**NORTH
NORFOLK
DISTRICT
COUNCIL**

Norfolk Vanguard Offshore Wind Farm

**REPRESENTATIONS IN RESPECT OF LETTER
FROM SECRETARY OF STATE FOR
BUSINESS, ENERGY & INDUSTRIAL
STRATEGY DATED 06 DEC 2019**

28 FEB 2020

Title:
2.11 Important hedgerows plan (sheet 13 of 42)

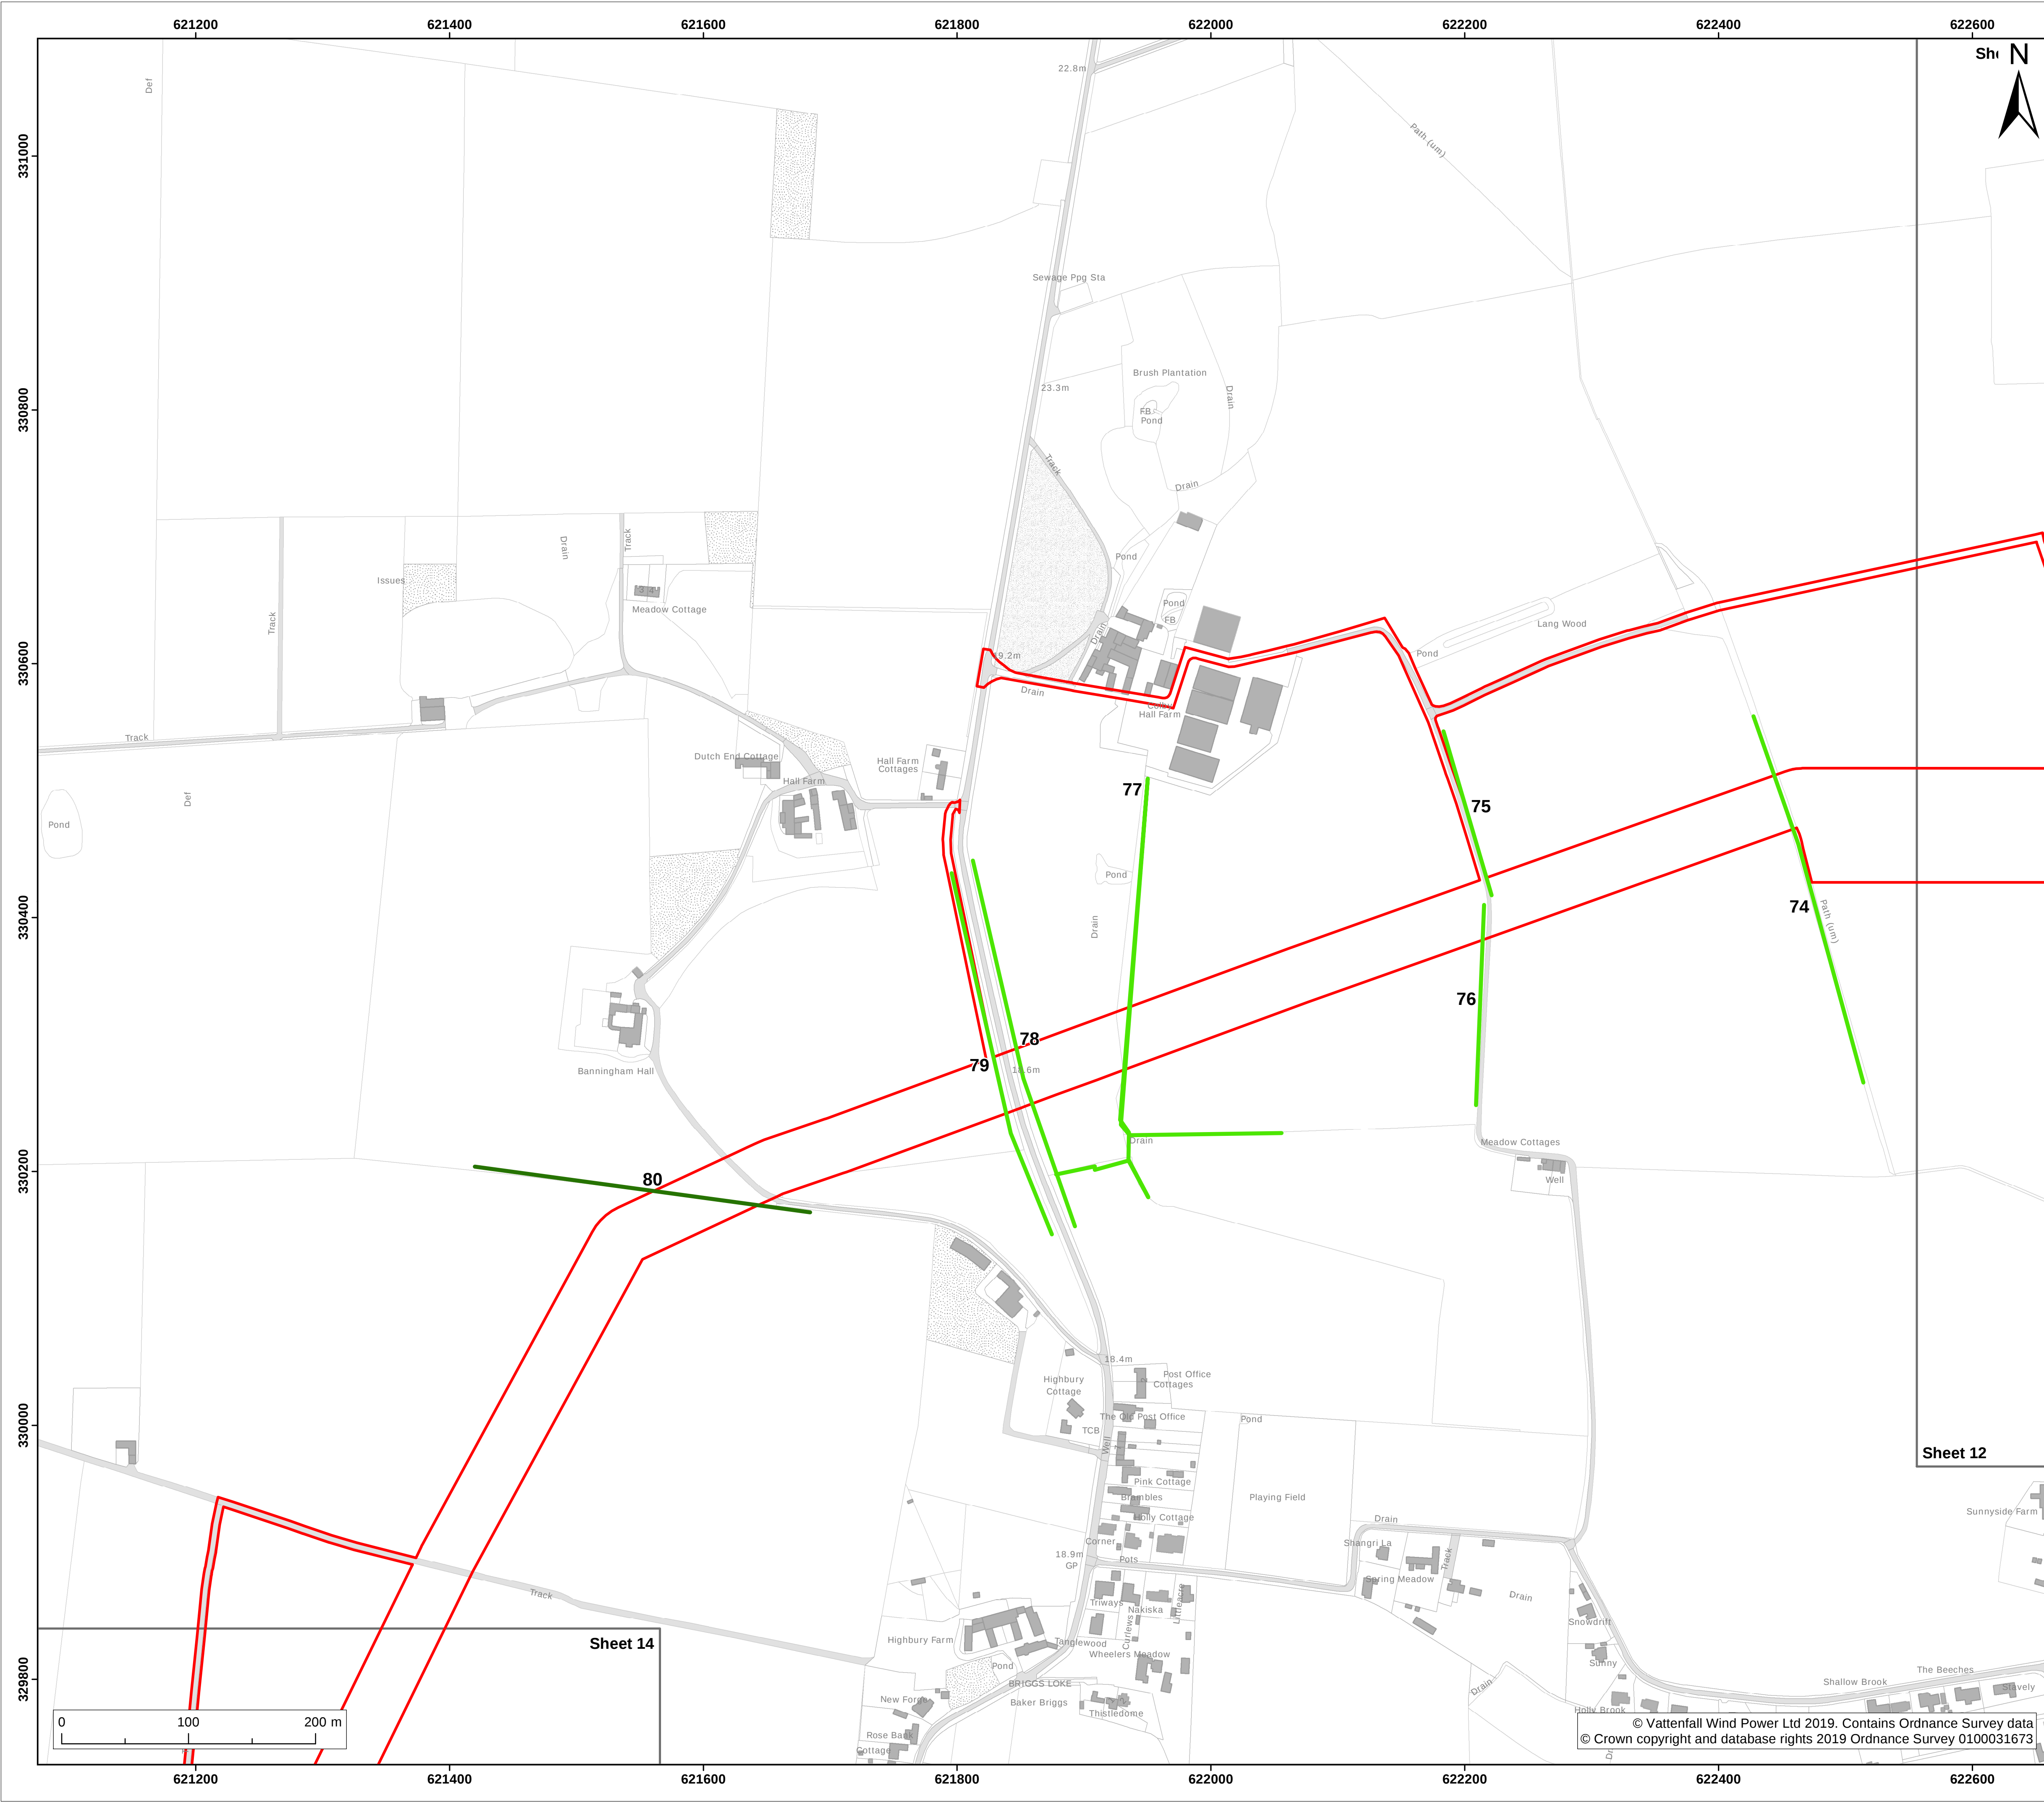
document, the ExA should be aware of the Important Hedgerows Plan prepared by the applicant for Norfolk Boreas [APP-018] (see **Appendix D**) where sheet 13 of 42 relates to the Colby Road area. This plan identifies six 'Important Hedgerows' affected by the project in this area alone.

- 2.4. In discussing this matter with the applicant, particularly with regard to alternative access points, NNDC has suggested consideration of an alternative vehicular access point to the north of the proposed cable corridor - see annotated plan of the proposal attached at **Appendix B** submitted to ExA for Norfolk Boreas at Deadline 5. This would be located at a point where there is an existing break in the tree line on the western side of Colby Road at the entrance to Hall Farm and Hall Farm Cottages. Existing access tracks could be partly used to form a new works access entrance with no loss of trees on this side of the road. On the eastern side of Colby Road, a new access could be created through the existing hedge. Whilst this may require removal of one or two semi-mature trees, the advantage of using this location is that replacement trees (and hedging) could be planted where gaps are created because the access would fall outside of the permanent easement area. These two accesses could allow new running track to be laid which will enable access to the trenchless crossing under Colby Road and thus negating the need to remove sections of three Important Hedgerows No.77, 78 and 79.

- 2.7. NNDC consider that Norfolk Vanguard Requirement 16 (17) (Detailed design parameters onshore) should be amended to include passing under Church Lane, Colby via trenchless installation techniques.
